TOWN OF SOUTHWEST HARBOR

LOWER TOWN PIER IMPROVEMENTS  
SOUTHWEST HARBOR, MAINE

ADDENDUM #2

MAY 27, 2009

**TYPICAL HANDRAIL POST DETAIL**

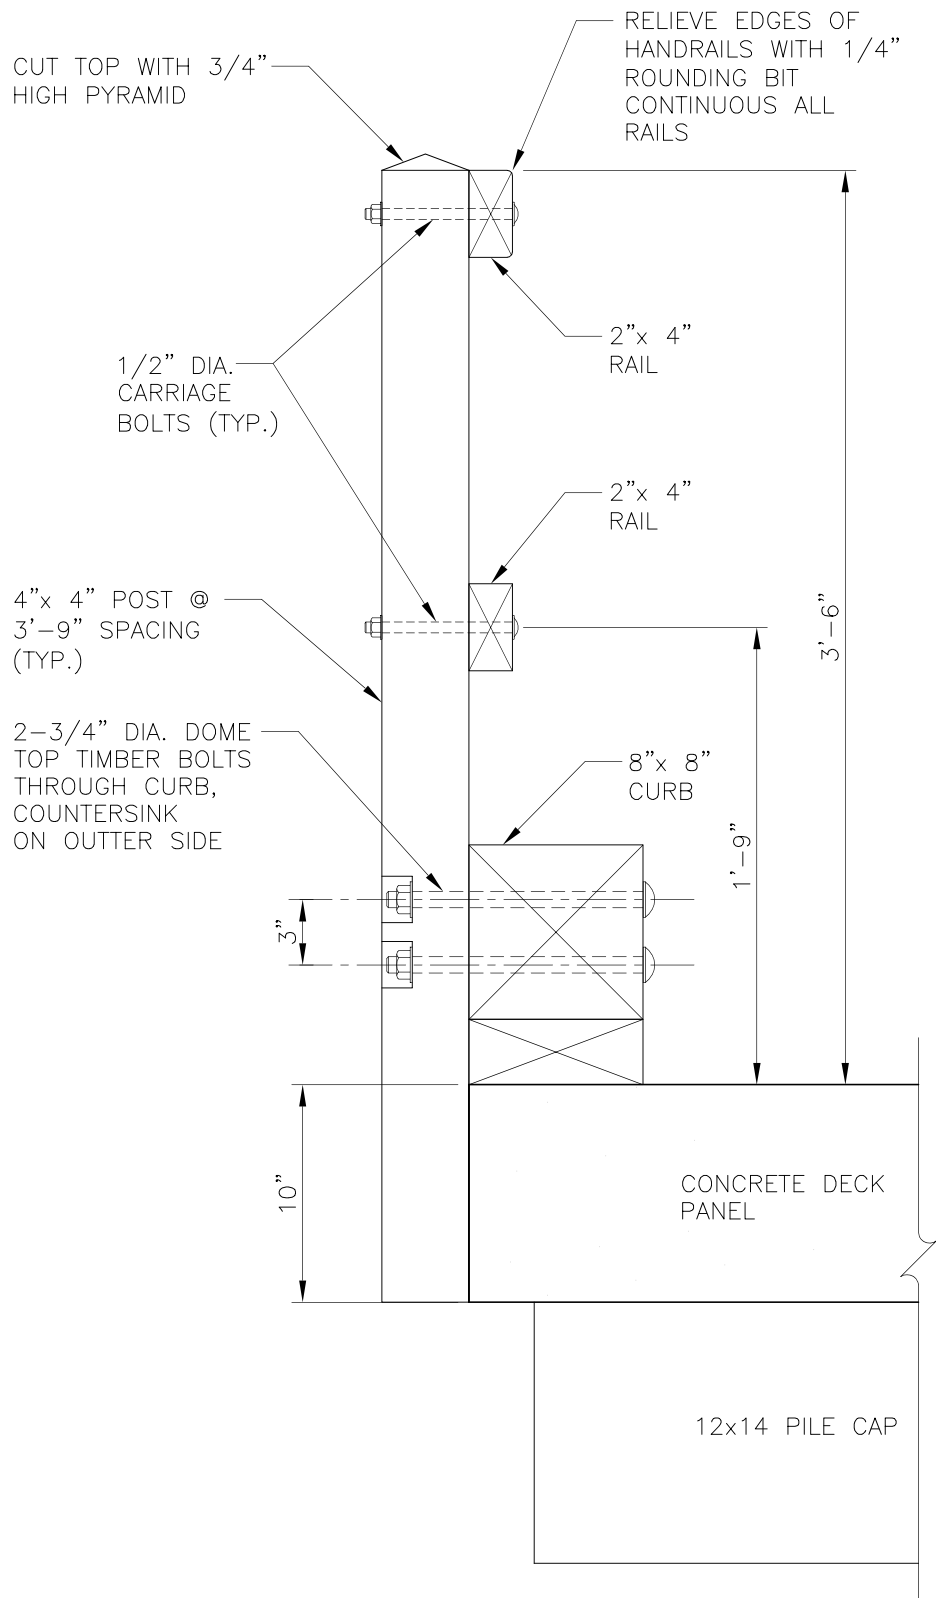
2. Drawing Sheet 5
  - a. Handrail posts are to be 6'-0" o.c. on the North Side Elevation.
  - b. Rails are 2x4 size and located at the top and center of the posts, as shown in enclosed detail.
  - c. All handrail timber shall be pressure treated Southern Pine, No.1 grade. Treatment shall be UC4B ACQ, Copper Azole, or MCQ.
  - d. The pipe pile on the west corner shall be driven open ended to refusal. A welded cap is required on the top but no concrete fill is required. Touchup paint any damage to the coating from driving or welding, using mfr recommended repair material.
